ENGINEERING CHANGE NOTICE

Page 1 of 21. ECN **634620**Proj.
ECN

5. Project Title/No./Work Order No. Interim Status Groundwater Monitoring Plan for the Nonradioactive Dangerous Waste Landfill, Hanford, Washington	6. Bldg./Sys./Fac. No. NRDWL	7. Impact Level QE

8. Document Numbers Changed by this ECN (includes sheet no. and rev.) WHC-SD-EN-AP-026, Rev. 0	9. Related ECN No(s). N/A	10. Related PO No. N/A
11a. Modification Work <input type="checkbox"/> Yes (fill out Blk. 11b) <input checked="" type="checkbox"/> No (NA Blks. 11b, 11c, 11d)	11b. Work Package No. N/A	11c. Modification Work Complete N/A _____ Cog. Engineer Signature & Date	11d. Restored to Original Condition (Temp. or Standby ECN only) N/A _____ Cog. Engineer Signature & Date

Figure 13. Location Map Showing Proposed New Monitoring Wells.

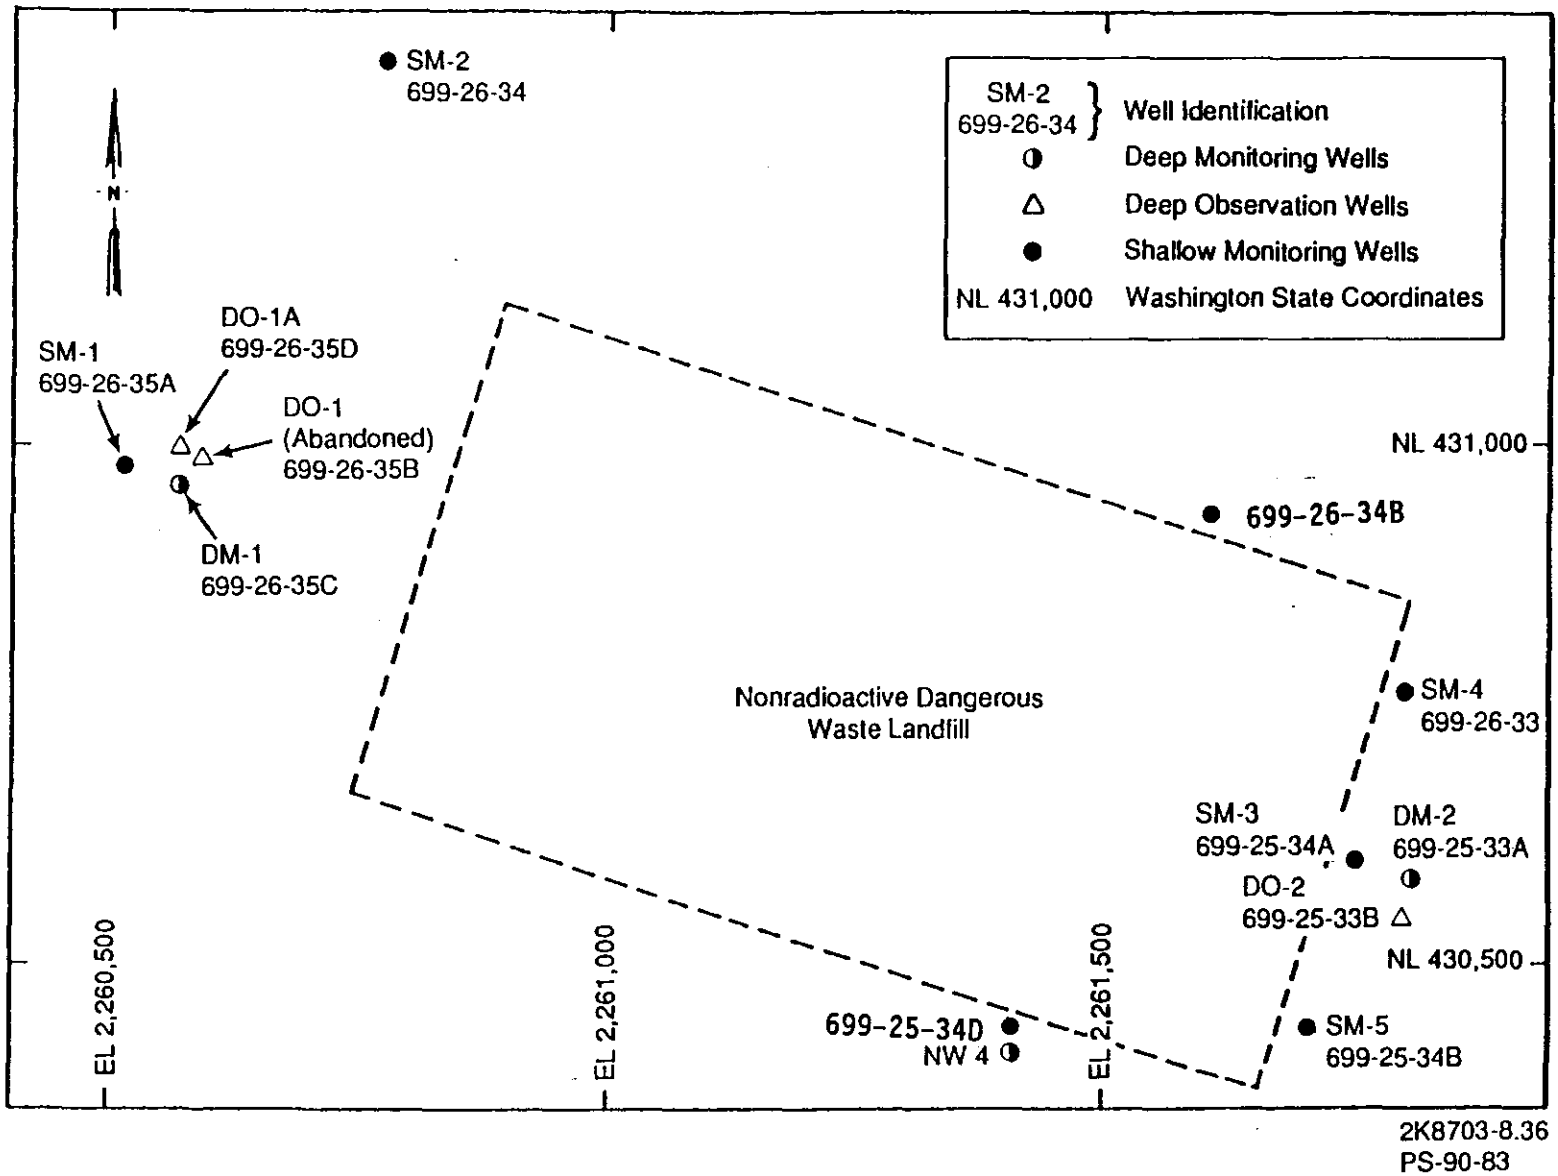
~~Three additional monitoring wells. Two new wells were completed in the top of the unconfined aquifer in 1992. and A deep groundwater monitoring and characterization is planned for expanding the initial groundwater monitoring network.~~ Estimated coordinates and construction details for ~~this wells are~~

presented in Table 2 and shown in Figure 13. The addition of these wells is not necessarily intended to represent the final groundwater monitoring network. Additional monitoring wells may be required to achieve full compliance with state and federal regulations. The placement of any additional new wells will depend on results of water level measurements, water quality analyses, hydrogeologic information, and tracer tests collected from this initial monitoring network.

~~Two shallow groundwater monitoring wells and a deep groundwater monitoring well will be installed around the NRDWL, starting in fiscal year 1992 when funding is available. The justification for the location of the three new monitoring wells is based on uncertainties in groundwater flow directions and the need for characterization of the deeper portions of the unconfined aquifer beneath the site.~~

~~One shallow well will be installed on the north side of the NRDWL, and two, one deep and one shallow, on the south side of the site (Figure 13). The well on the north side is intended to supplement the NRDWL downgradient detection network. The shallow well located on the south side of the landfill will help in separating potential groundwater impacts from the NRDWL and the SWL. The locations of the shallow groundwater monitoring wells are indicated by MEMO modeling results that indicate a minimum monitoring efficiency of at least 93%, essentially independent of groundwater flow direction (DOE 1990). These wells will ensure that the uncertainties between the regional and local groundwater flow directions will be adequately covered. The deep monitoring well, located adjacent to the shallow monitoring well on the south side of the site, will provide for deep aquifer characterization and for detection of DNAPL contaminants on the down dip side of the NRDWL.~~
